INDIANA DEPARTMENT OF TRANSPORTATION

STANDARDS COMMITTEE MEETING

APPROVED MINUTES

September 18, 2008 Standards Committee Meeting

5. SIGN POST REFLECTORS

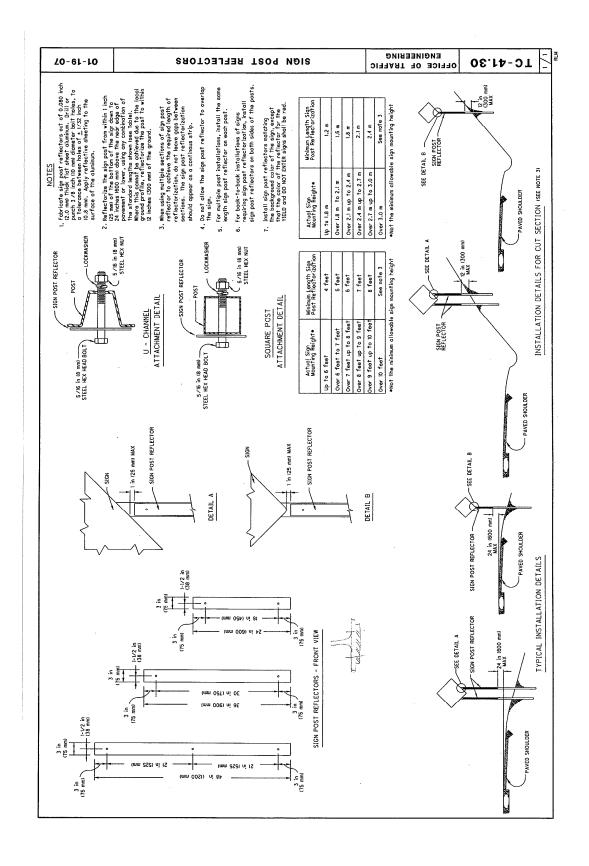
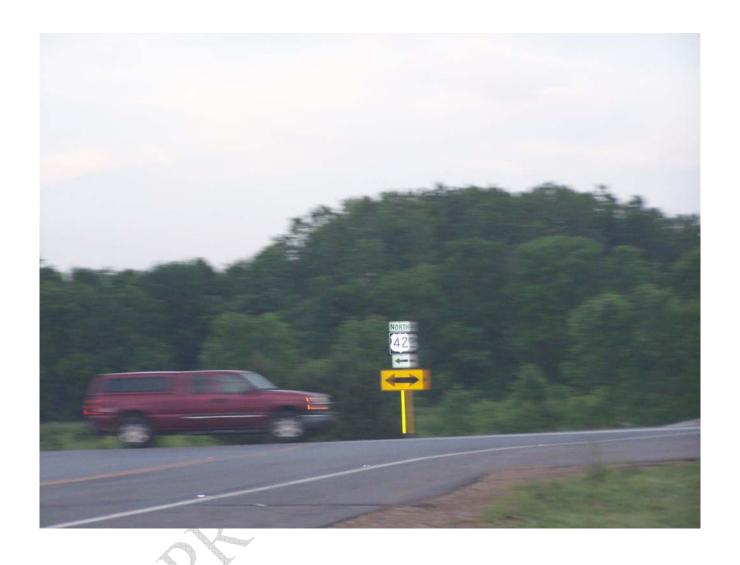
PROBLEM(S) ENCOUNTERED: Enhance the visibility of important Regulatory signs and Warning Signs by using SIGN POST REFLECTORS. Signs such as STOP signs, STOP AHEAD signs, YIELD signs, YIELD AHEAD signs, WRONG WAY signs, CHEVRONS and CURVE signs can be greatly enhanced by additional illumination.

PROPOSED SOLUTION: Require the use of SIGN POST REFLECTORS. Sign post reflectors are used both in Ohio and Michigan. It is recommended that a standard sheet be developed and the design manual be revised to give guidance on how and when this is to be done.

807-LTFD-09, CONVENTIONAL LIGHT FOUNDATION FOR 33" CONCRETE MEDIAL WALL INSTALLATION

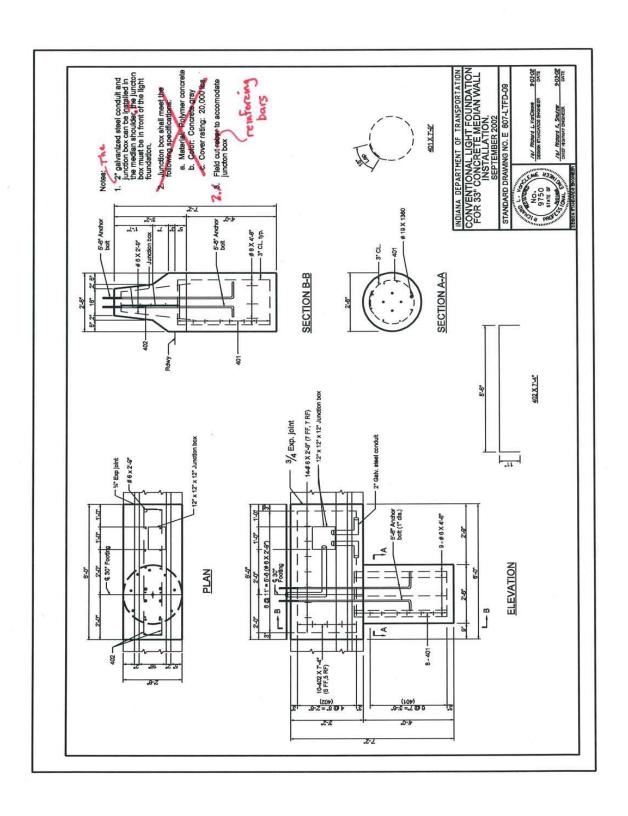
PROBLEM(S) ENCOUNTERED: Removal of material specification note (Note 2)
from standard drawing 807-LTFD-09.

PROPOSED SOLUTION: Insert material specification from standard drawing into 920.01(g). Renumber existing 920.01(g) Shop Drawings to 920.01(h) Shop Drawings.
